FINAL PLAT OF THE
FADAL ADDITION
SURVEY OF 1.37 ACRES OF LAND
SITUATED IN THE J.M. STEPHENS SURVEY
McLENNAN COUNTY, TEXAS

RE: Final Plat of the Fadal Addition, Phase II, Lots 1-8, Block 1 Response to City Comments – 1st Review

STANDARD FINAL PLAT REVIEW

Subdivision Name: Final Plat of the Fadal Addition, Phase II, Lots 1-8, Block 1

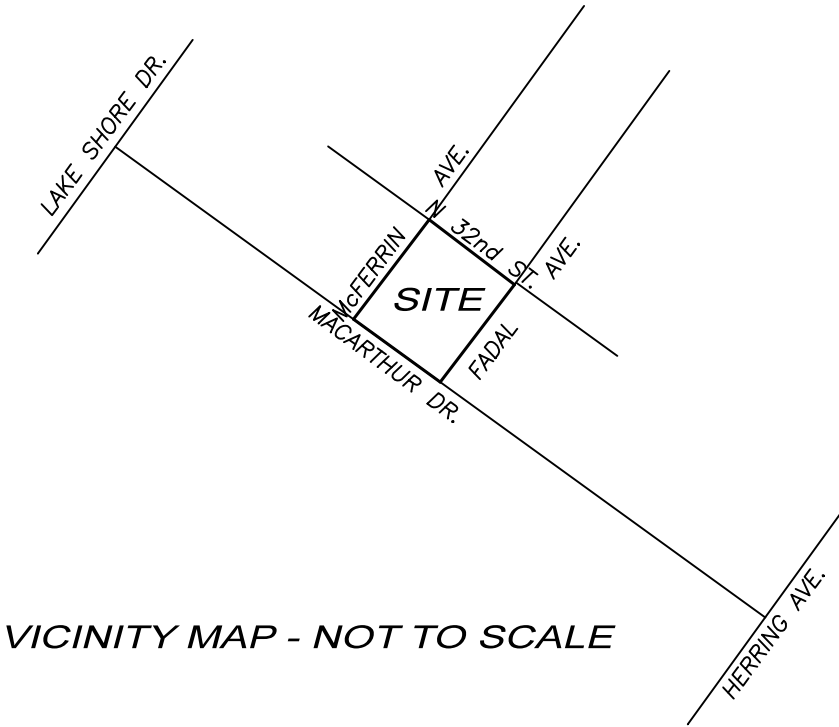
6. **Comment** – McFerrin does not meet minimum local road width of 50 ft with curb and gutter. Demonstrate minimum 25 ft (half of required right of way) exists between the proposed lots and the existing McFerrin centerline. Dedicate the necessary portion of right of way to meet the 25 ft requirement on the property's side of McFerrin.

Response – Since the current right-of-way width of McFerrin Ave. is 45.05', we have shown a 2.475' ROW dedication on this proposed plat.

DRAINAGE AREA MAP

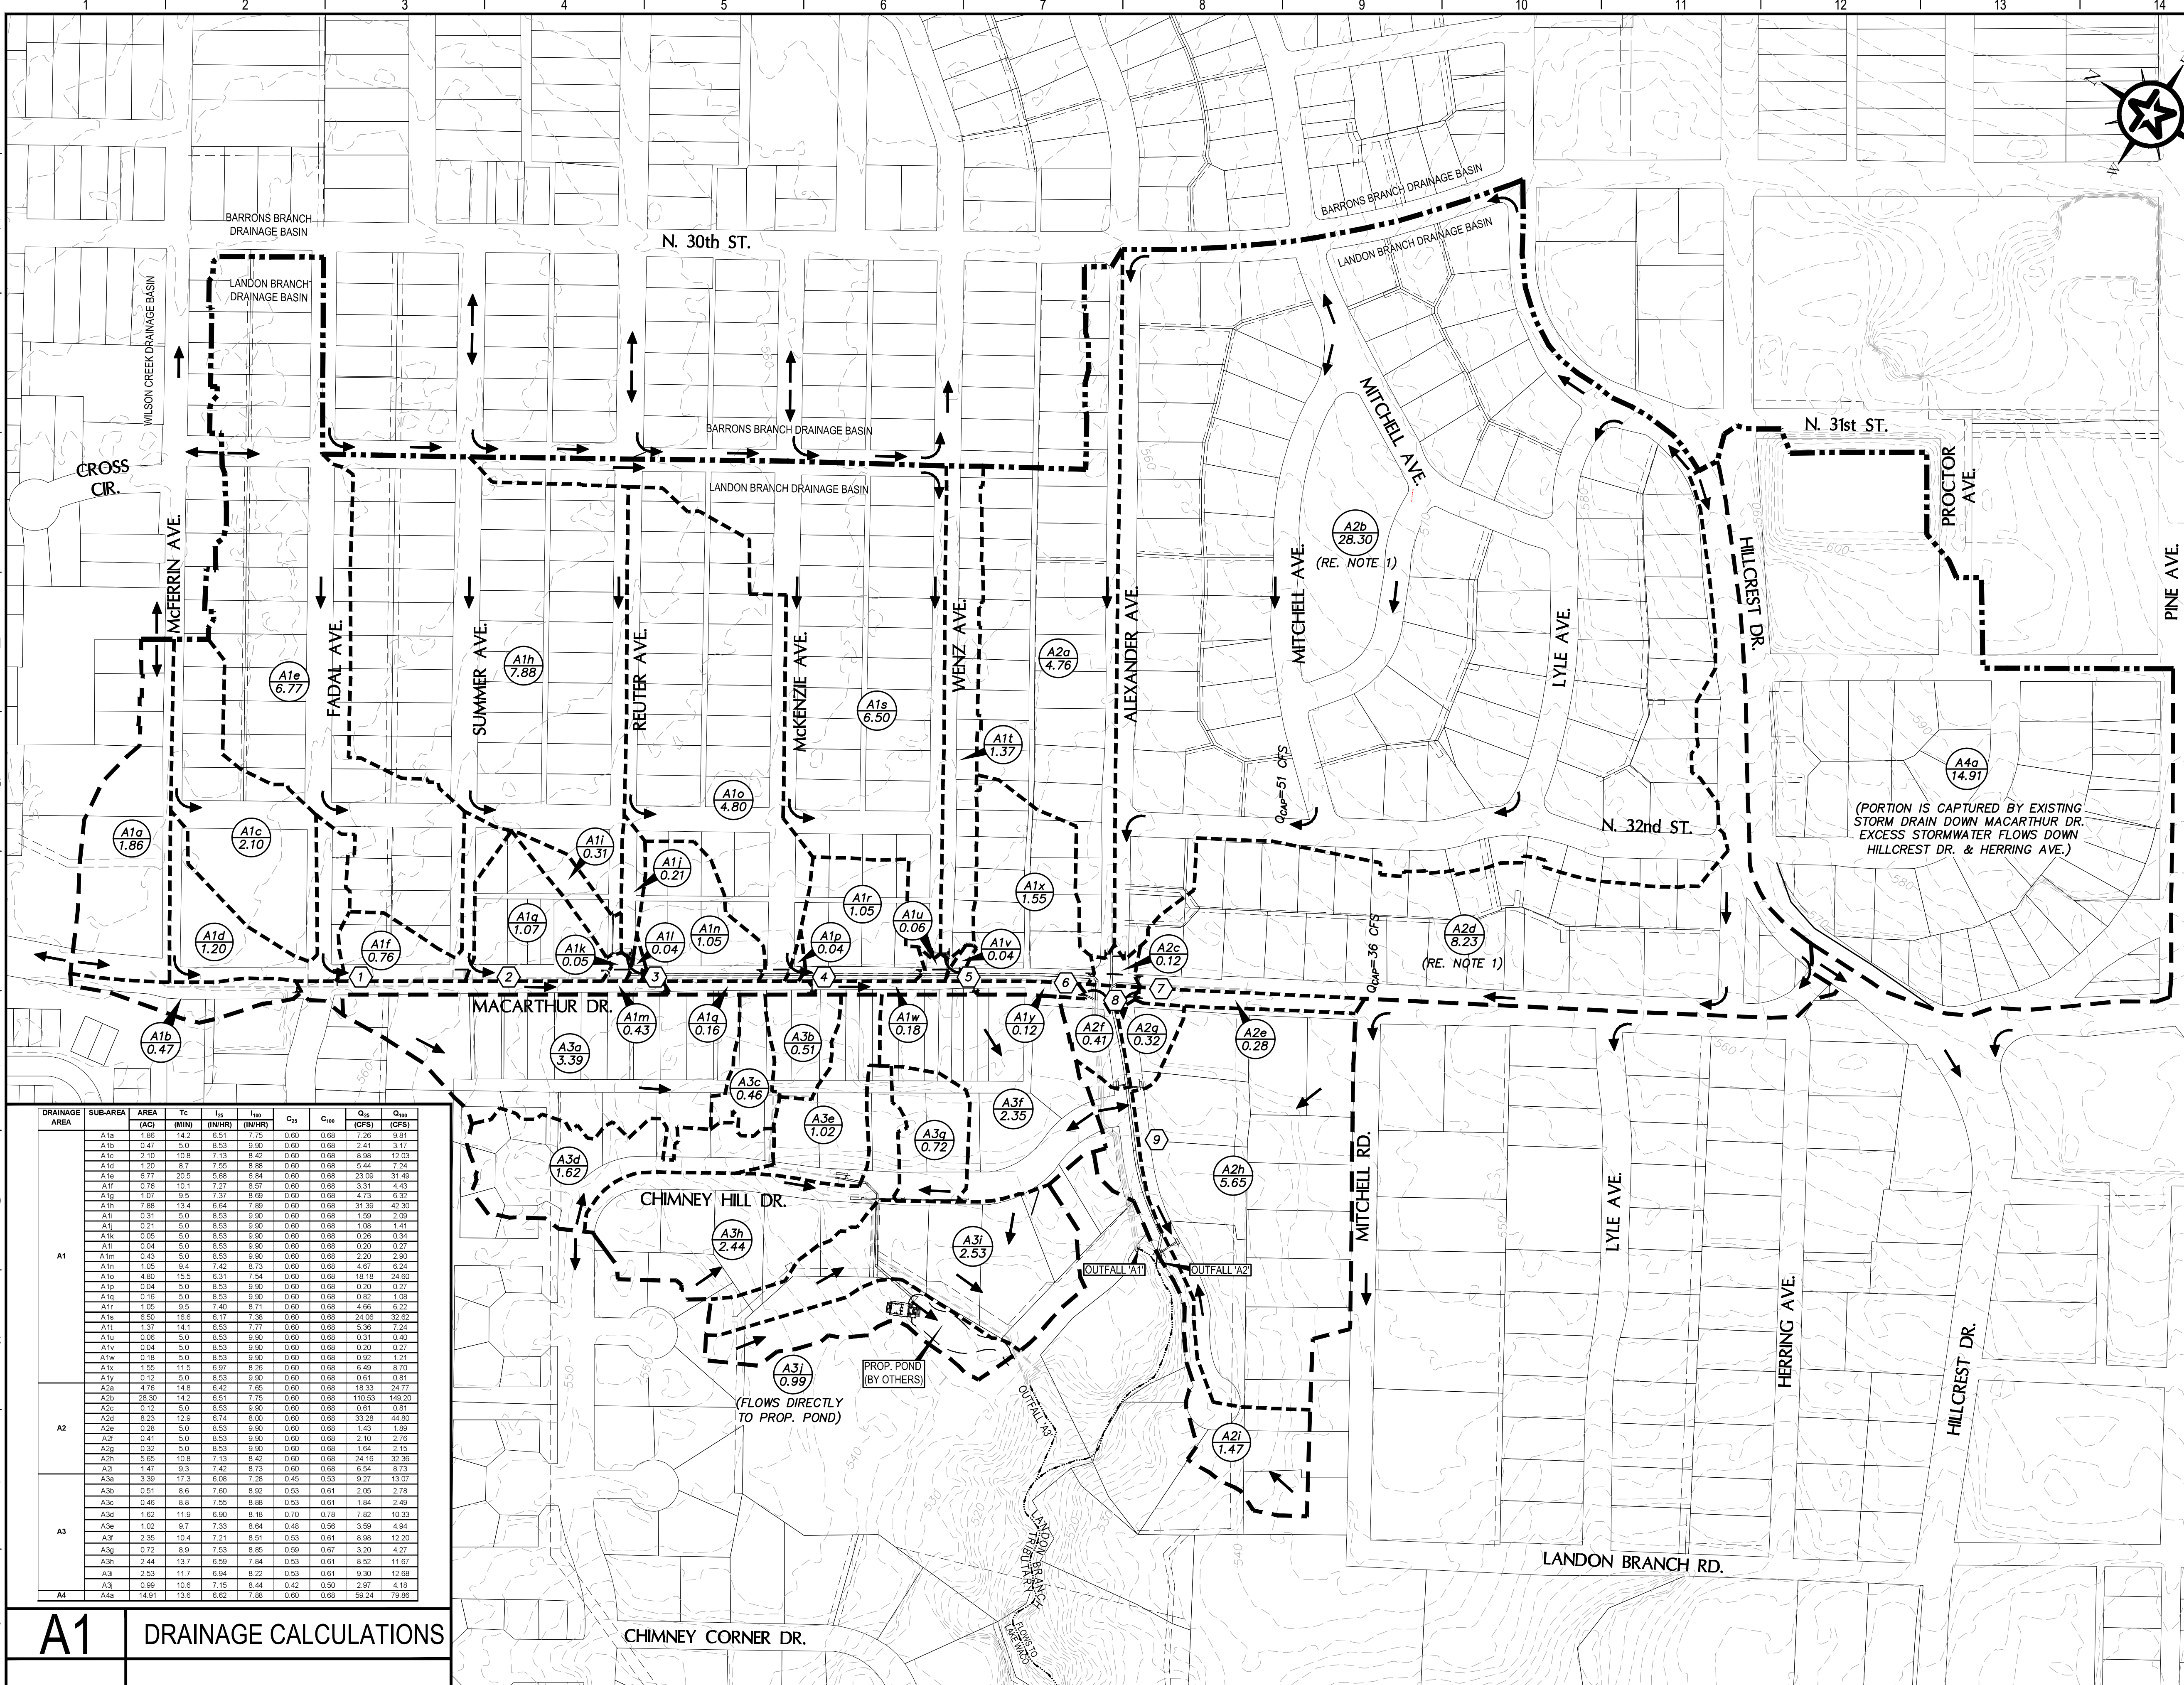
7. **Comment** – Sheet 5 Drainage Area Map does not comply with the City of Waco Stormwater Management Regulations. Provide some combination of detention and/or LID design to comply with the regulation's post-development discharge and treatment requirements or provide a request for waiver. If a request for waiver is made, provide proposed impervious cover for the calculation of the fee-in-lieu of detention in accordance with the City's fee schedule. **Response – Please refer to plan note provided on plan sheet 7, Drainage Area Map. As stated, this proposed development has been taken into account with the city's Chimney Hill Area Drainage Improvements project prepared by Walker Partners (see attached).**
City condition not satisfied - see notes on Page 3.

Section 5.202 - Sheet 5 Drainage Area Map does not comply with the City of Waco Stormwater Management Regulations. Provide some combination of detention and/or LID design to comply with the regulation's post-development discharge and treatment requirements or provide a request for waiver. If a request for waiver is made, provide proposed impervious cover for the calculation of the fee-in-lieu of detention in accordance with the City's fee schedule.

Chimney Hill Area Drainage Improvements plan may support the waiver request; however, it does not relieve the developer of the fee-in-lieu of detention requirement. Calculate the net impervious area for the site so that the appropriate fee may be determined.
